TENNESSEE VALLEY AUTHORITY

In the Matter of the Application of) Docket Nos. 50-390
Tennessee Valley Authority) 50-391

At the request of J. Menz, the NRC Radiological Assessment Branch reviewer for the Watts Bar Nuclear Plant, TVA has reviewed the accessibility of the fuel transfer tube. During a telephone conference call on February 27, 1979, with Mr. Menz and other NRC representatives, TVA confirmed that the Watts Bar design precluded inadvertent access to the fuel transfer tube. Enclosed are revisions which will be made in the next amendment to the Watts Bar Final Safety Analysis Report (FSAR) documenting this position. These revisions include changes to FSAR pages 12.3-13 and 12.3-14 and a new figure 12.3-12, "Fuel Transfer Tube Shielding Details."

**WATTS BAR NUCLEAR PLANT
 FINAL SAFETY
 ANALYSIS REPORT**

**FUEL TRANSFER TUBE
 SHIELDING DETAILS
 FIGURE 12.3-12**

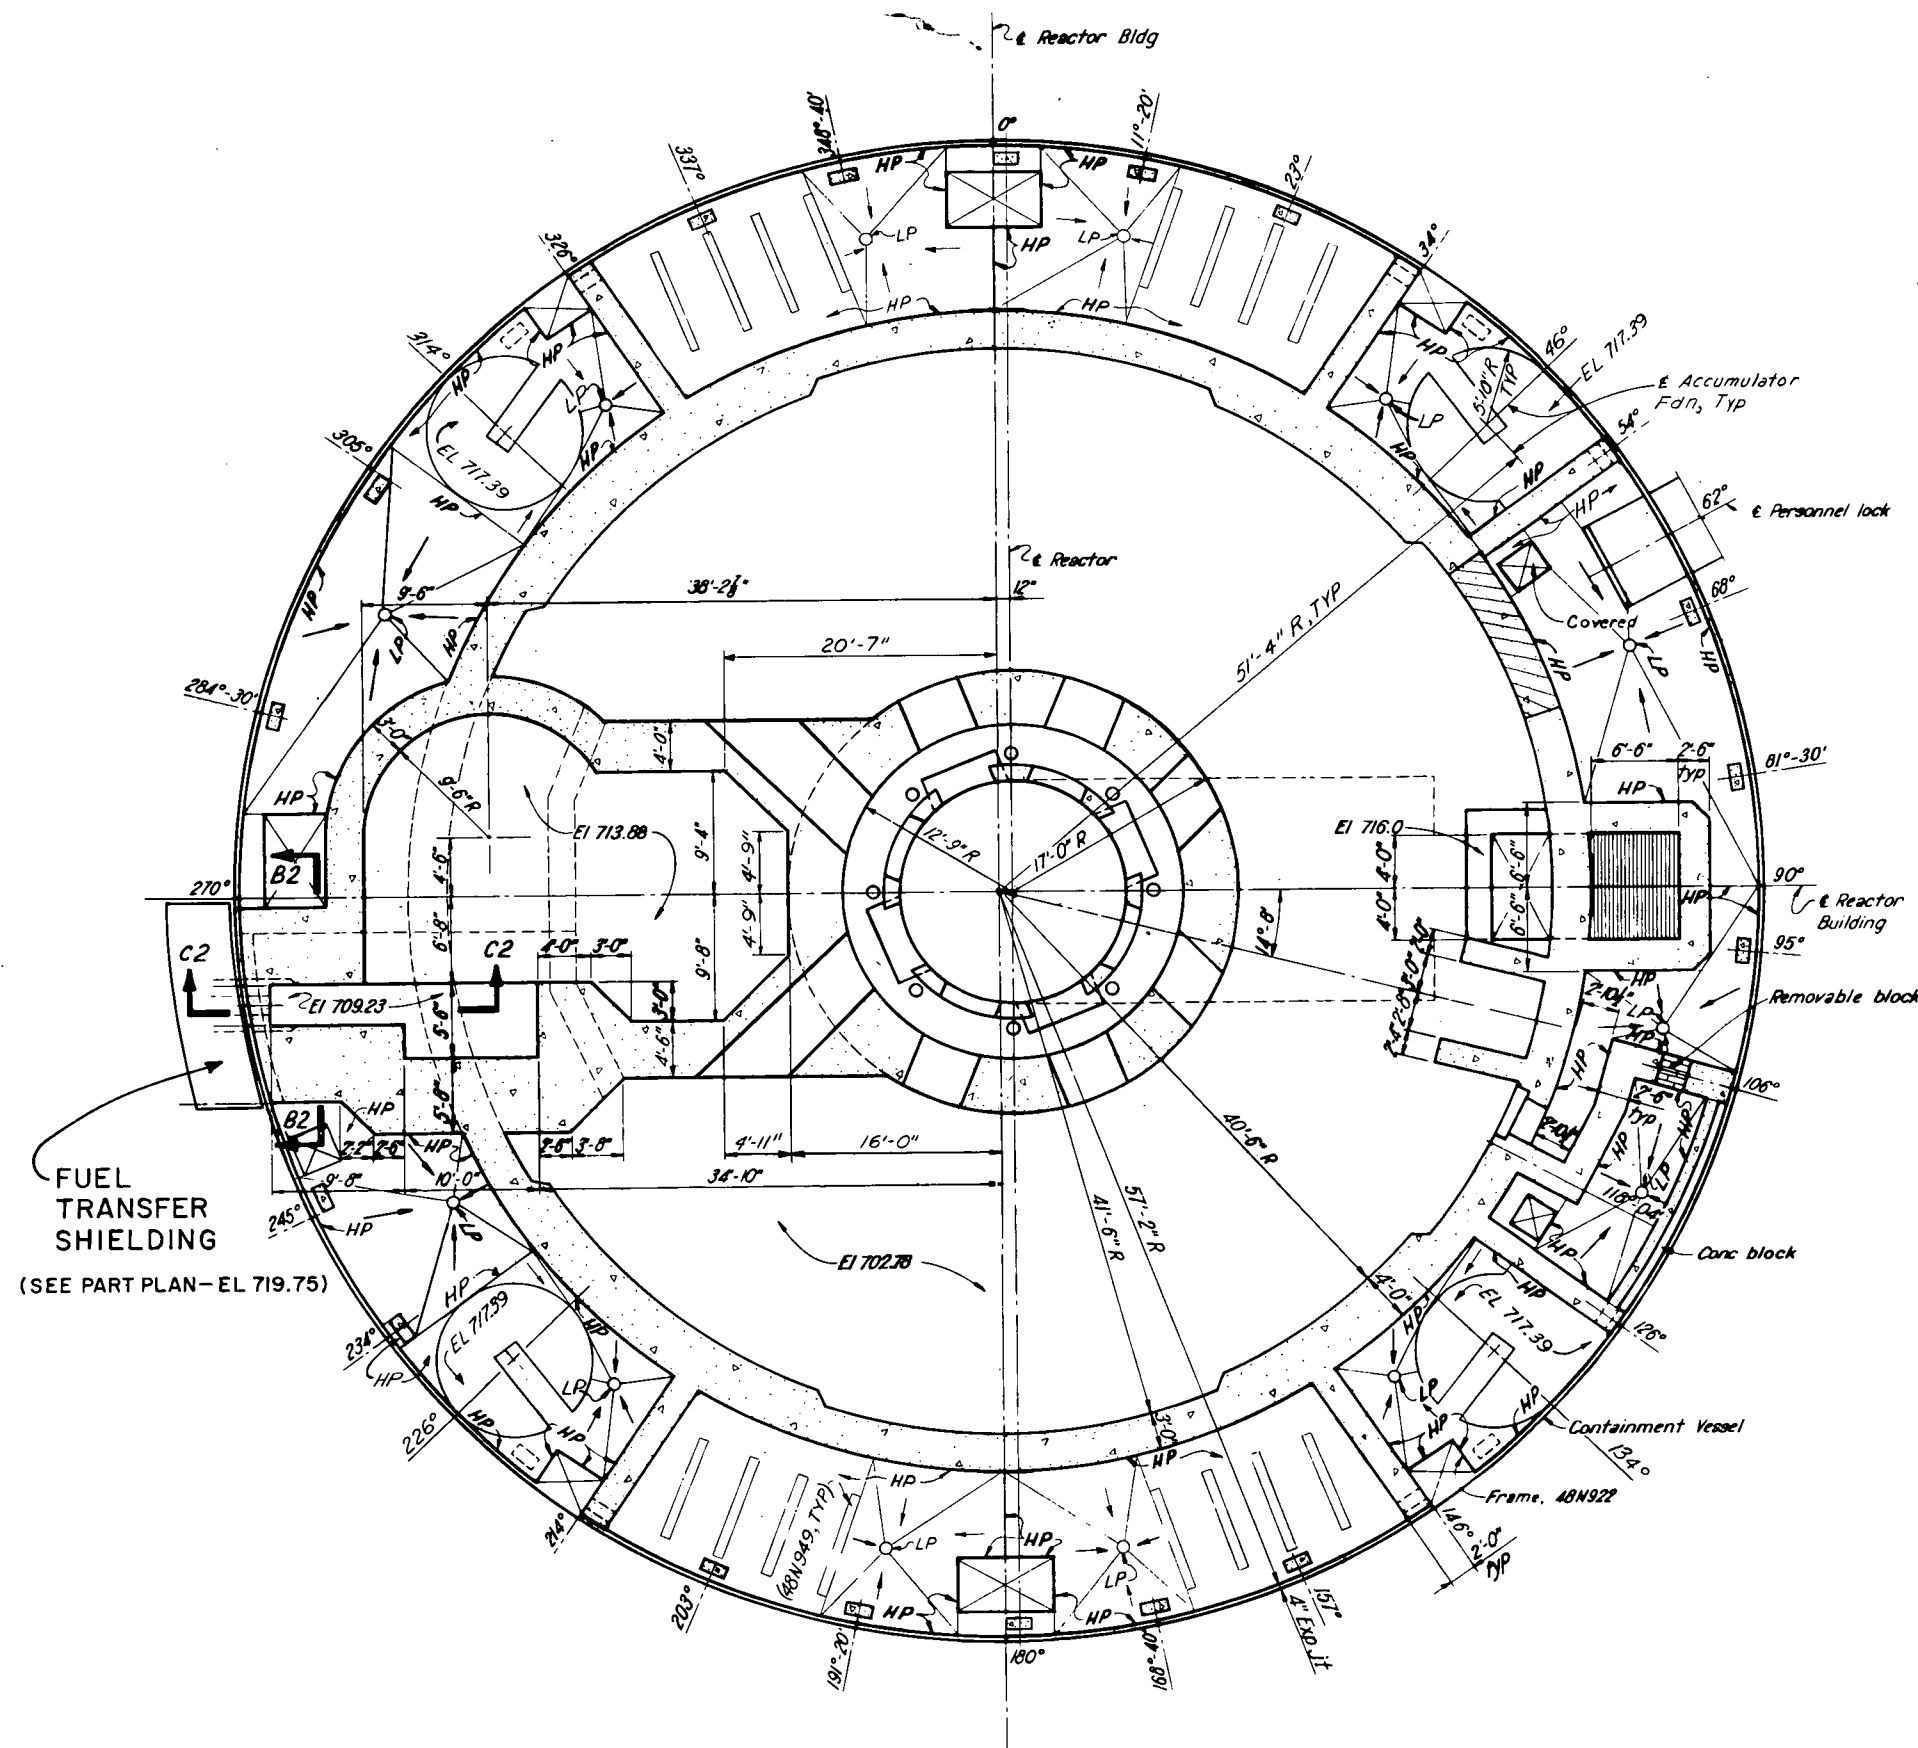
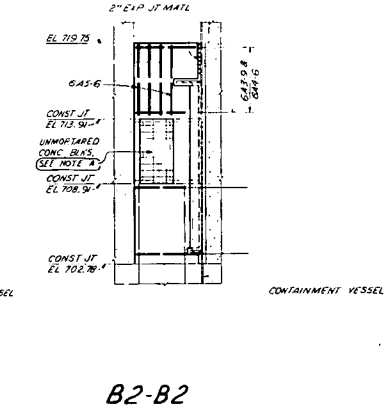
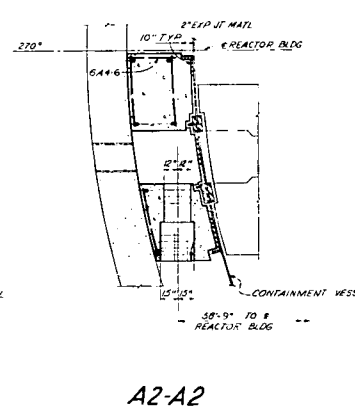
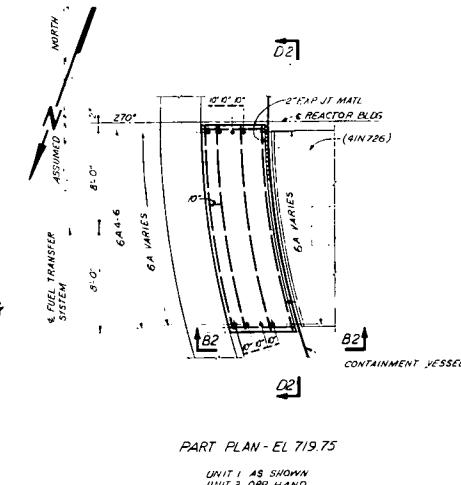
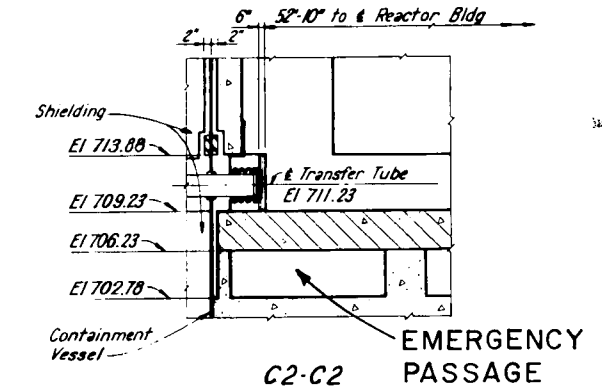
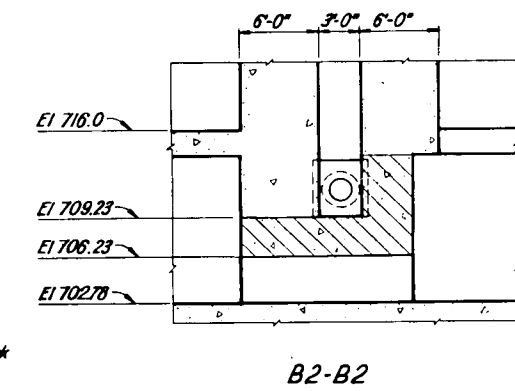
A small access opening provided through the shielding in the annulus to allow inspection of the fuel transfer tube. This opening is normally filled with solid concrete blocks which are removed only when access for inspection purposes is required.

The minimum water shield above the active fuel region of a spent fuel assembly as it moves from the reactor vessel to the storage position in the spent fuel pool is 10.5 feet except when the assembly is in the fuel transfer tube. The design of the transfer equipment incorporates restraints to assure that this minimum water shield is maintained. The calculated exposure rate to a person at the water surface resulting from a fuel assembly at its maximum elevation during transfer is less than 1 mrem/hr. Except for an emergency passageway under the fuel assembly tilting device in the refueling canal, the transfer of spent fuel assemblies does not generate any high radiation areas in accessible plant areas. The maximum shielding between the fuel assembly and the emergency passageway is 3 feet 0 inch of heavy concrete (density = 148 lb/ft³). The
